INTERNAL MEMORANDUM

OBSERVATIONS BY THE ENGINEERING AND HIGHWAYS DIVISION IN RESPECT OF DEVELOPMENT AFFECTING EXISTING OR PROPOSED PUBLICLY MAINTAINED HIGHWAY

Residential development (200 units), engineering works, access formation, landscape, drainage and associated works at Dragon Park Abercanaid Merthyr Tydfil

Figure 3.2 Local amenities within walking distance

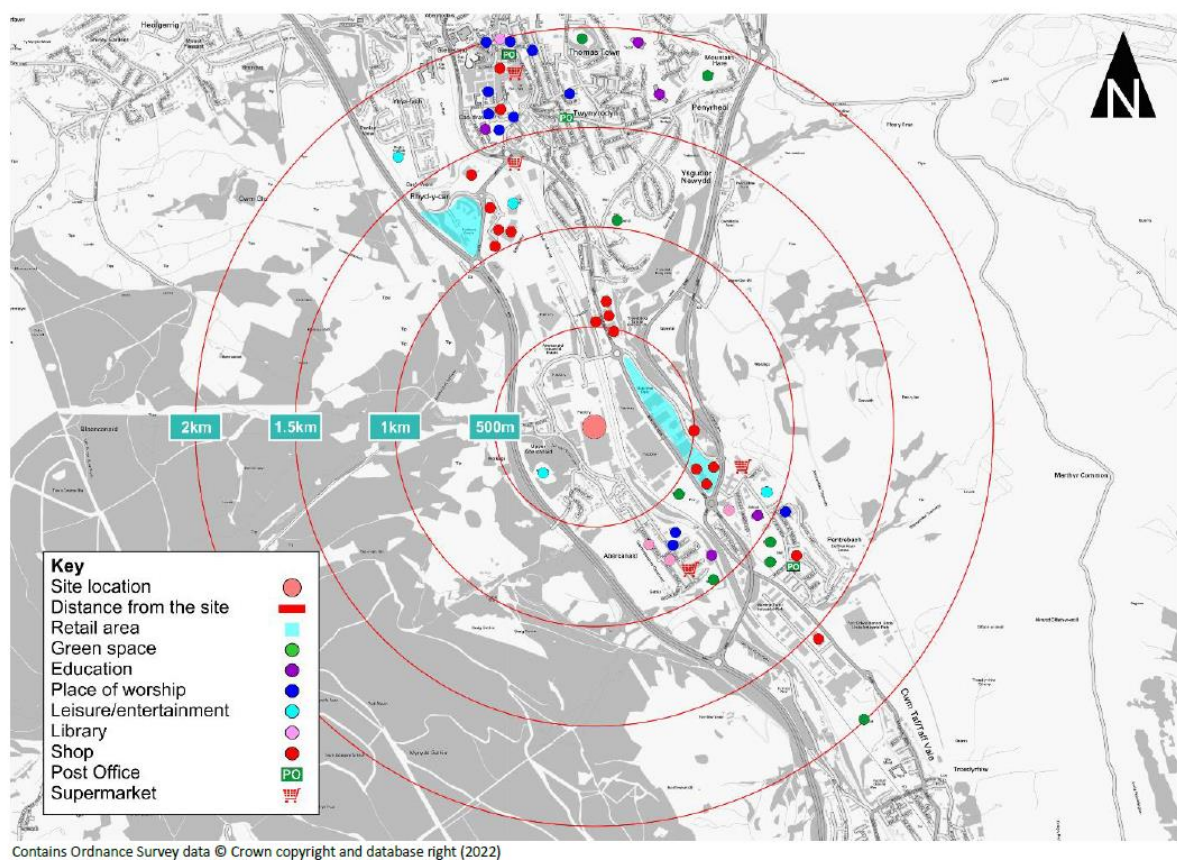
The above indicates various distances from the site 'as the crow flies' and not via available walking routes. Nevertheless, there are numerous facilities and amenities located within an acceptable walking distance from the proposed development and the local highway network includes sufficient pedestrian facilities to encourage trips to such facilities and amenities on foot.

Figure 3.3 Local cycle routes

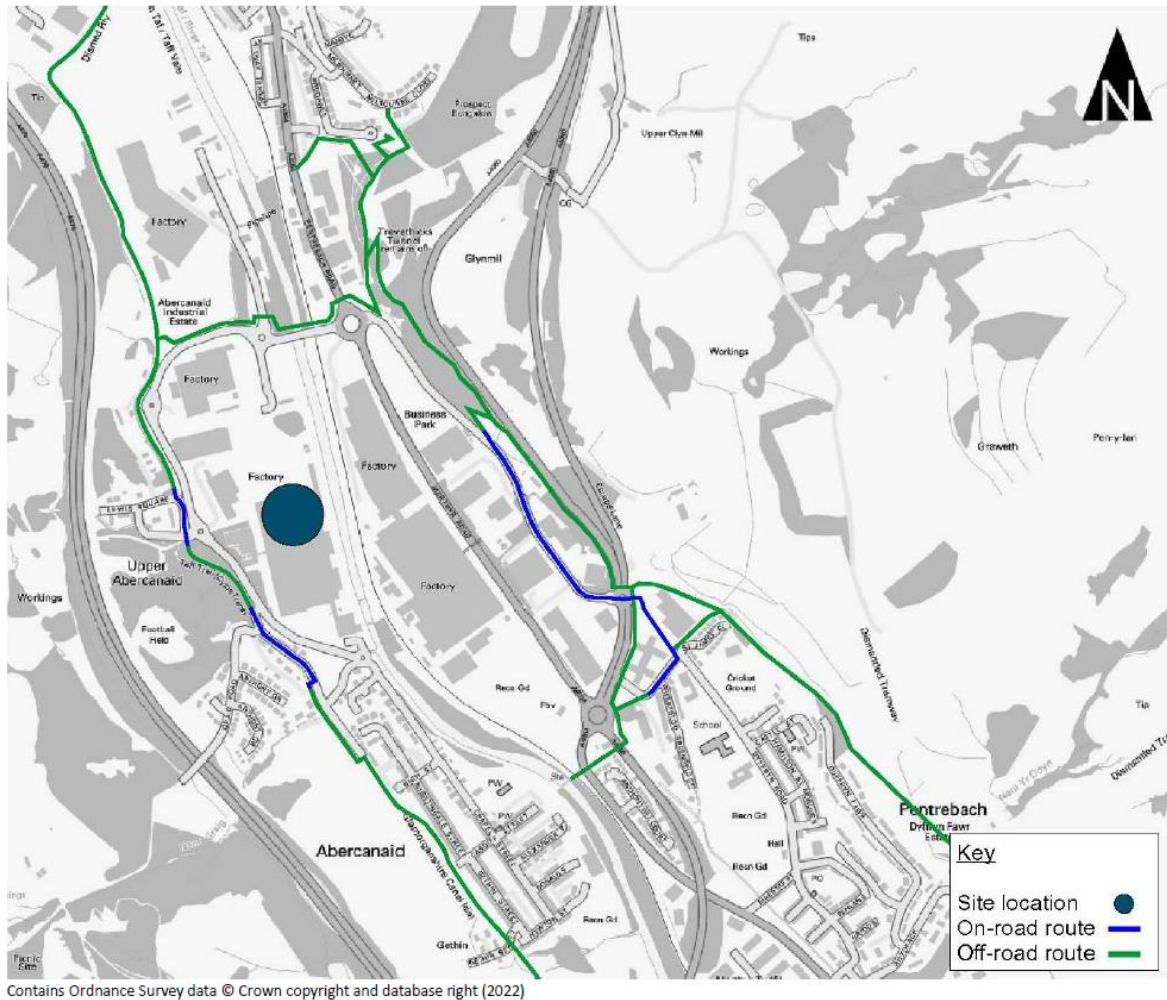
As can be seen from the above, the site is within easy cycling distance of numerous designated cycling routes. Although no designated routes connect directly to the proposed development the local highway network within the vicinity of the development is sufficient to accommodate on-street cycling. As such, the facilities and amenities identified on figure 3.2 above are also readily accessible by cycle and the available designated cycle routes, particularly those that form part of the NCN, encourage trips further afield.

Figure 3.4 Local public transport infrastructure

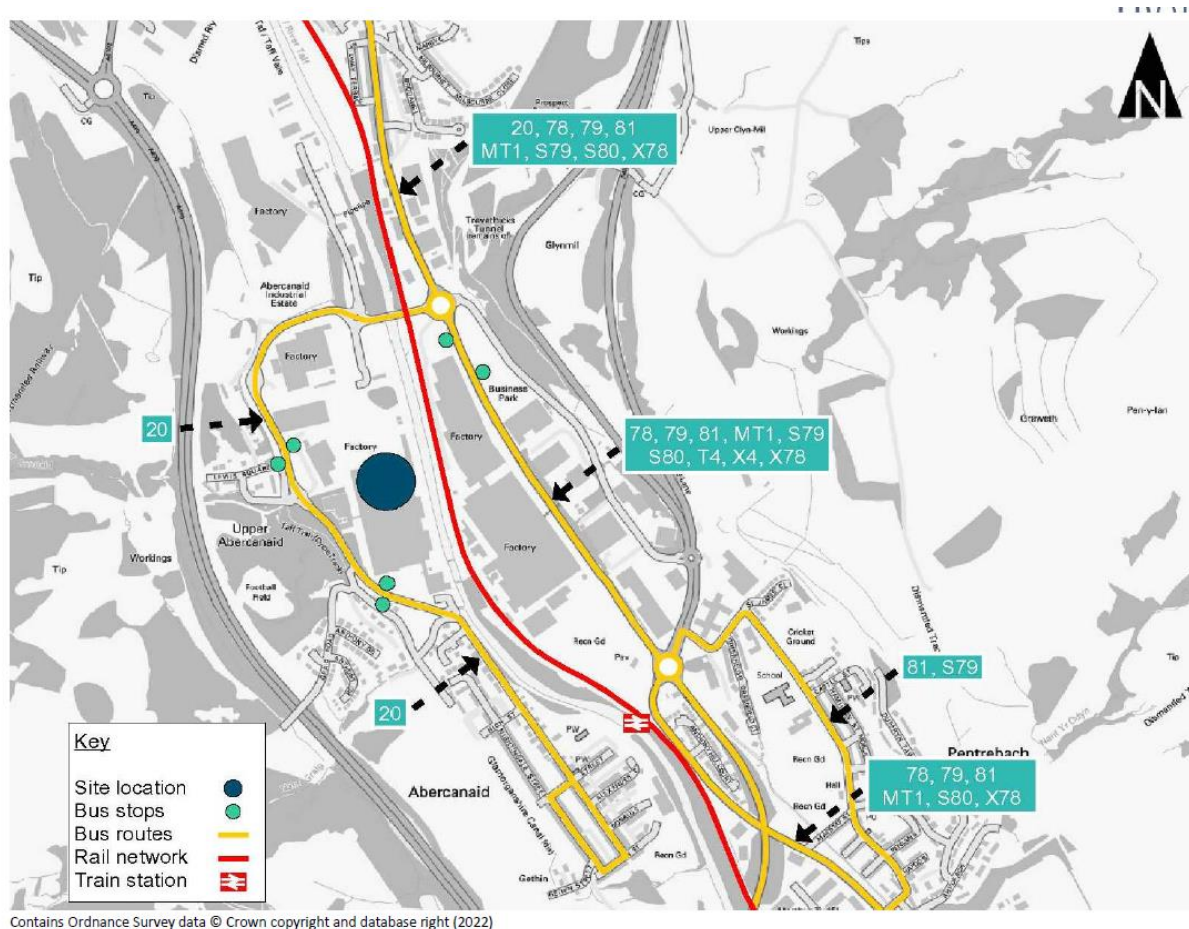
The nearest bus stops located to the proposed development are located to the west of the development on Abercanaid Road. However, these stops are served by route 24 which runs only 4 services a day in each direction between 0930 and 1730. Nevertheless, the development is within walking distance of other stops located on the A4054 Merthyr Road which provide a regular service to Merthyr Tydfil Bus Station and further afield. Furthermore, Pentrebach train station is located within walking distance which provides a regular service between Merthyr Tydfil and Cardiff. As such, the development is considered to be sufficiently served by public transport.
